# SERVICE *No.* 966 BULLETIN

January 21, 1994

**SUBJECT:** TAIL SURFACES REPLACEMENT

PA-18-150 Super Cub

**SKETCH 1 - STABILIZER INSTALLATION**

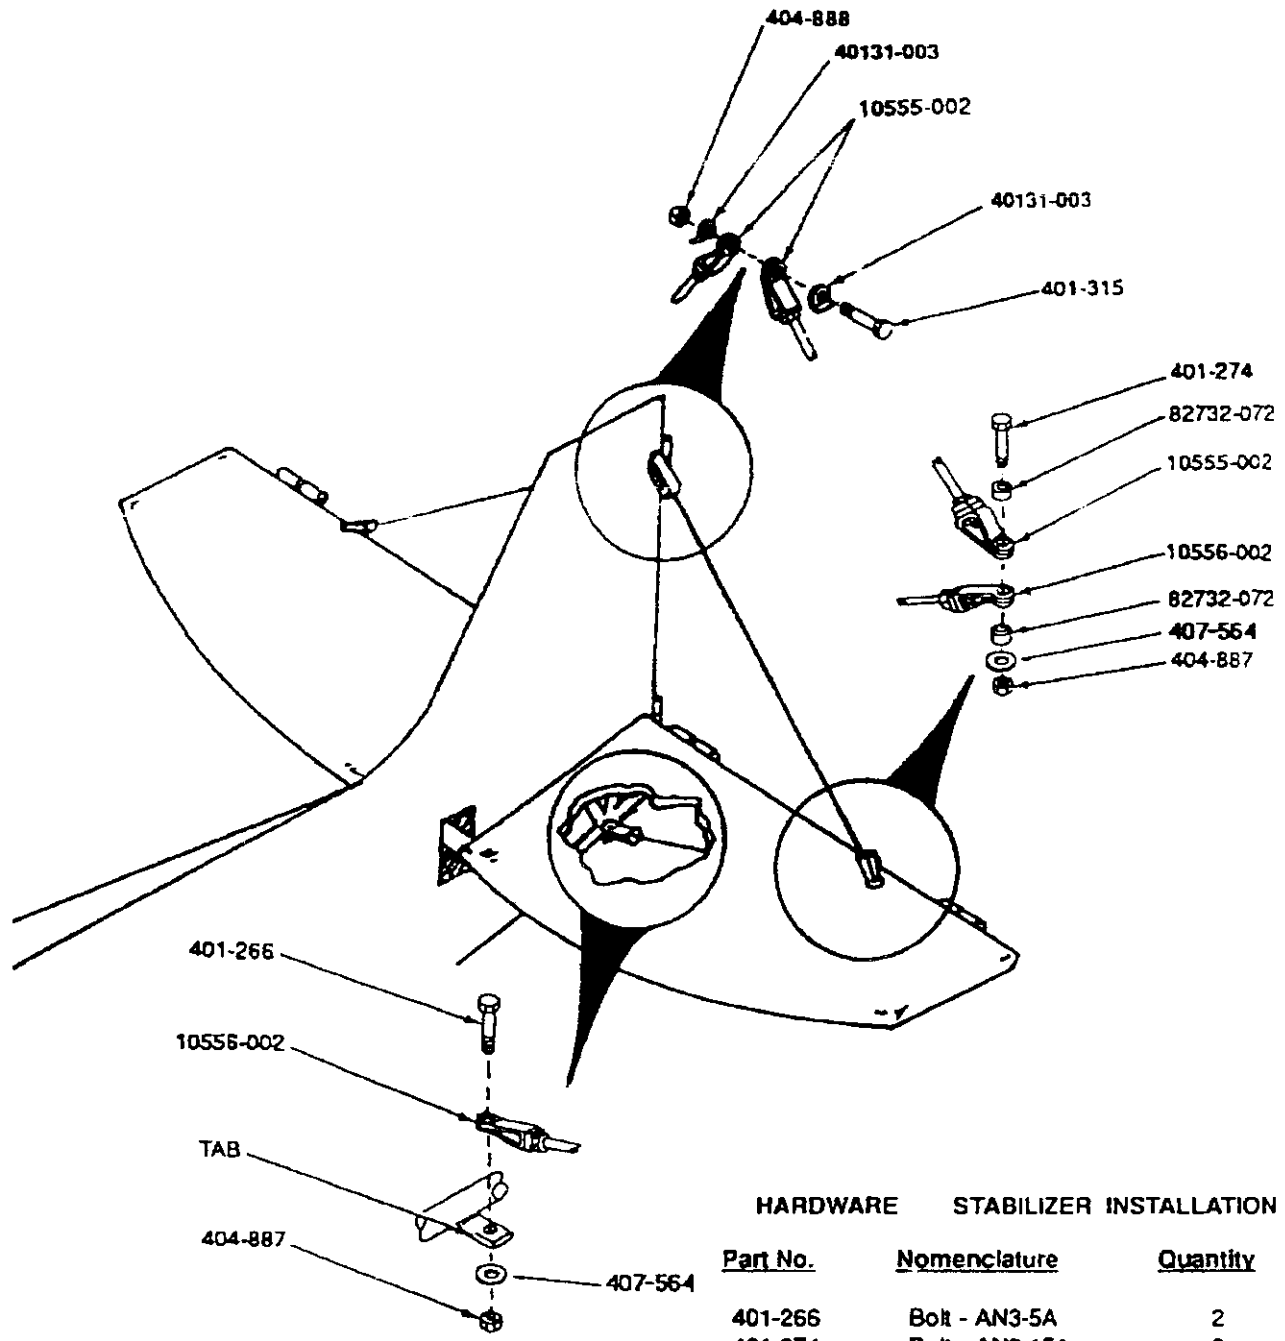
A. Identify the LEFT stabilizer and lay it on a suitable work surface. Apply a thin coat of all weather grease to the inside ends of the front and rear stabilizer tubes, then install the front and rear liner tubes in their proper locations and secure with the same hardware as removed.

B. Apply a thin coat of grease to the exposed ends of the liner tubes then install the stabilizer onto the aircraft until the stabilizer is tight against the mounting brackets.

C. Apply grease to the inside of the front and rear tubes of the RIGHT stabilizer and install it onto the ends of the liner tubes that protrude from the side of the fuselage. It may be necessary to have a second person hold the left stabilizer as a back up.

D. Make sure the drain grommets on the trailing edges of both stabilizers are on the bottom of both surfaces.

SKETCH 3 - STABILIZER INSTALLATION AND RIGGING

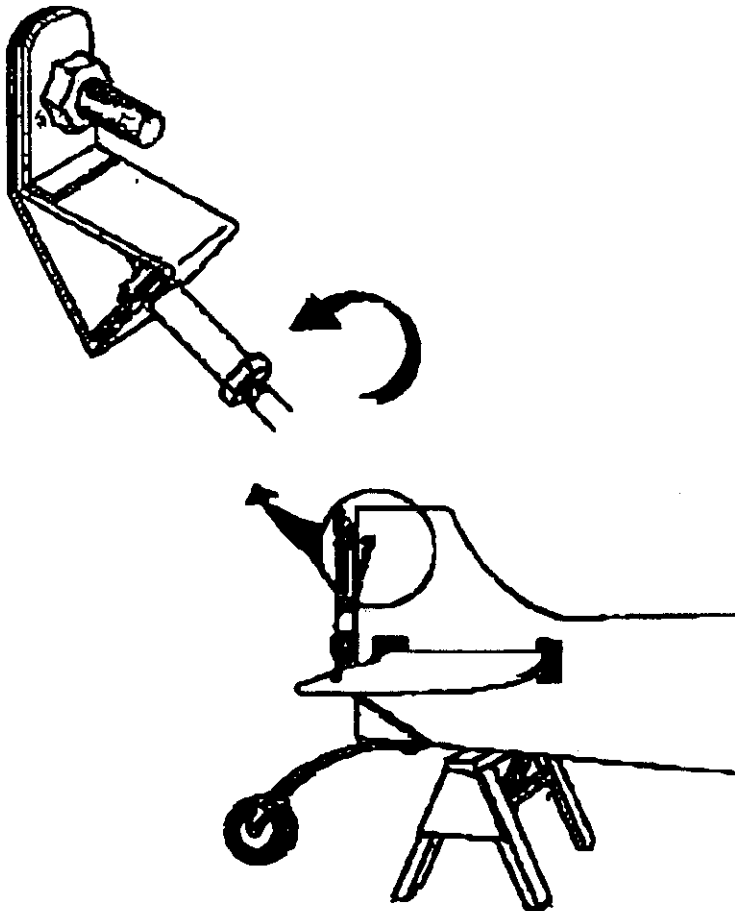
- A. Place the tail of the aircraft on a sawhorse so the stabilizers are at a comfortable height, then place a level across the rear seat cross tube and level the fuselage laterally by deflating a tire.

- B. Place a 30 inch level on top of the LEFT stabilizer trailing edge tube and adjust the lower brace wire end fittings evenly while lifting up on the stabilizer until the surface is level.

- C. Level the RIGHT stabilizer in the same manner as the left, making sure that equal threads are exposed at each end of the lower wires.
- D. Tighten both upper wires evenly and recheck the levelness of the horizontal stabilizers but do not bother with the vertical fin at this time.

- E. When the stabilizers are level tighten all wires evenly until a deflection of 1/2 inch yields 10 pounds when the middle of one of the upper and lower wires is pulled in a 90 degree direction with a fish scale.

- F. Adjust the vertical fin to a perpendicular position by placing the level vertically along side of the fin trailing edge tube and move the upper portion of the fin to the left or right by loosening one of the upper wires and tightening the other wire equally to maintain the wire tension but yet move the fin to a perfectly vertical position.

- G. Make sure all (8) jam nuts on the wire end fittings are tightened snugly.
